Application Reference: A006964015
Address of Site: 1095 WATERWORKS RD THE GAP QLD 4061

RE: Further advice requiring resolution prior to a decision

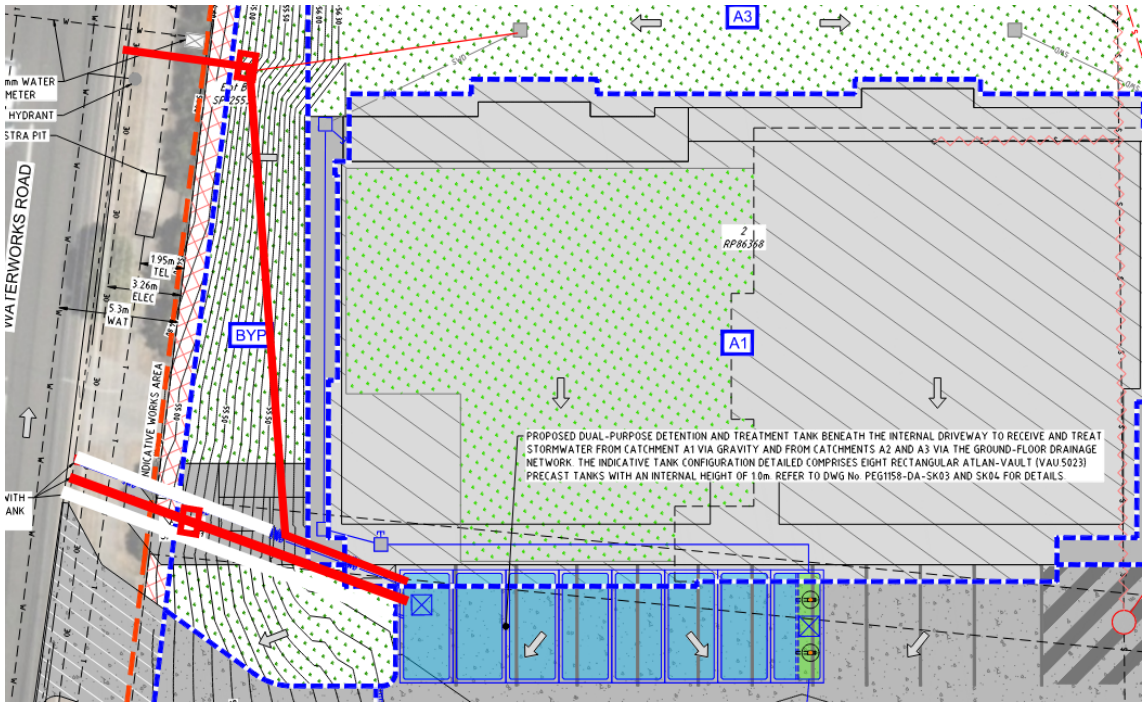
3) The proposed kerb adapters layout as shown on SK02-C is not supported. Multiple discharges within proximity to each other are considered a single discharge location. In accordance with PO1 and PO2 of the Stormwater code provide amended plans as follows:

a. Retain a discharge location where currently proposed and move the other discharge point towards the western boundary of the site by 10 to 15m.

b. At each discharge location a roof-water surcharge pit is to be provided, at the site boundary, to manage flows exceeding the capacity of the kerb adapters in major storm events, i.e., 1% AEP and extreme storm events.

c. As the permissible flow to kerb and channel at each location is 30L/s in a 5% AEP (as per roof-water design) storm event, revise the detention measures to ensure that the 5% AEP flows do not exceed this flow at any of the discharge locations.

See below a sketch of the required layout.
